Oral submission by Frank McDonald to the MetroLink oral hearing, March 27th, 2024

Figure 7. Plan Showing Horizontal Alignment (extract from ML1-JAI-EIA-ROUT_XX-DR-Y-04026)

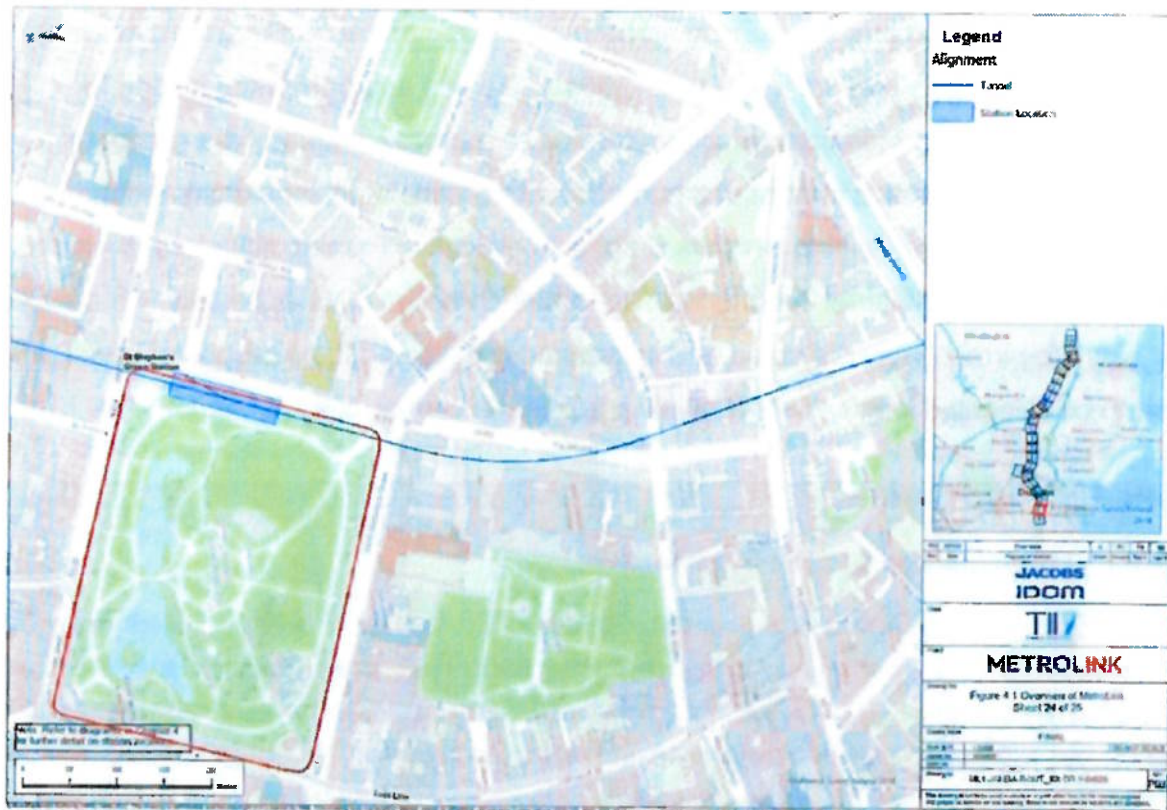
3.7 MetroLink’s engineers appear to have viewed the Green as a soft option for the excavation of a station box, rather than locating it on the roadway, which would have required the closure of St Stephen’s Green East to traffic for the duration of construction. Although the OPW has offered to “work jointly with TII to develop a solution that satisfies the requirement for a station in the vicinity of the Green but has no impact on the Park”, it would be preferable if An Bord Pleanála imposed a condition to relocate the station slightly further east, with access and egress on the public footpath, rather than the proposed canopied station entrance inside the park.
